**ADDENDUM NO. 2**

Re: Millbrook Central School District  
Bond Projects, Phase 1A  
At Millbrook Middle School  
SED No: 13-22-01-04-0-008-016

BBS File No. 25-237

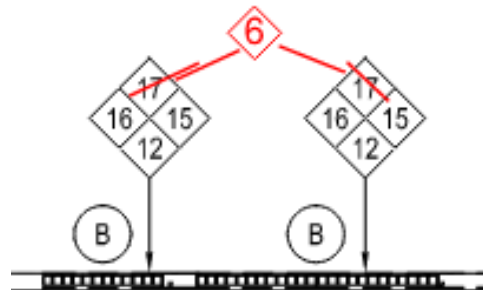
10. Demolition note 17 occurs on A1.01 at some of the gym openings but the note is not listed in the demo key notes legend. Please clarify,

**Answer: Replace note #17 with note #6, which is only found in the gymnasium (room #39).**

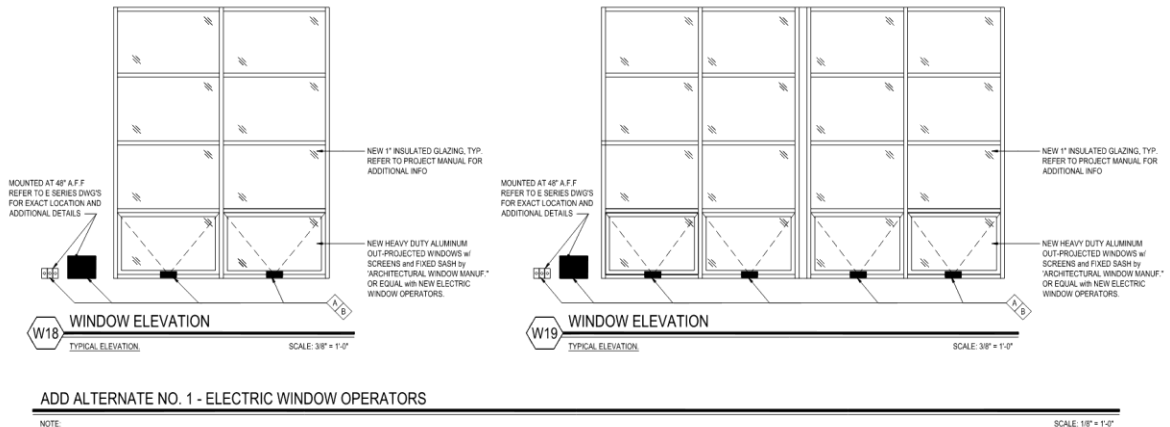
11. Construction keynote 8 on A2.01 says that the clearstory windows on south walls of each link corridor are by the window contractor. This would be curtain walls CW4 & CW5. Wouldn't these be part of the GC contract since they're in the link corridors? Why are these curtain walls in the WC scope but CW1, CW2, CW3 are in the GC scope? Who is responsible for constructing the openings for CW4 & CW5 clearstory windows?

**Answer: All work in the link corridor A & B is part of the GC scope including all windows and curtain wall systems as CW1, CW2, CW3, clear-story window, and fixed window.**

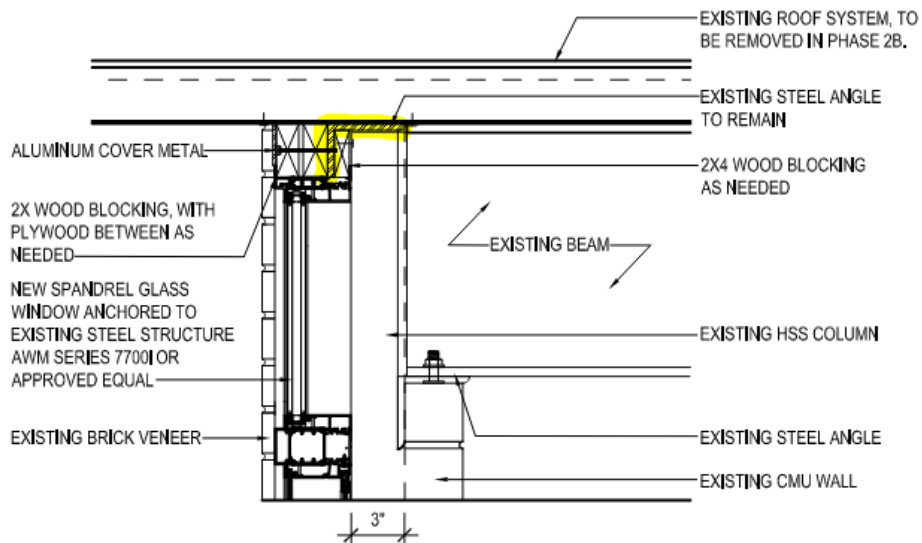
13. Security Glazing and Panel Notes on A8.01 says to include security film in "Locations as indicated on the drawings" but the drawings do not indicate where security film (SF) is required related to the curtain walls at the link corridors that are part of the GC contract. Please clarify.

**Answer:** Security glazing should be installed on exterior doors in both link corridors A & B, it is part of the GC scope of work to install security film on exterior doors as per the door schedule. The security film on all installed windows is part of added alternate No. # 2 on drawing sheet A8.03.
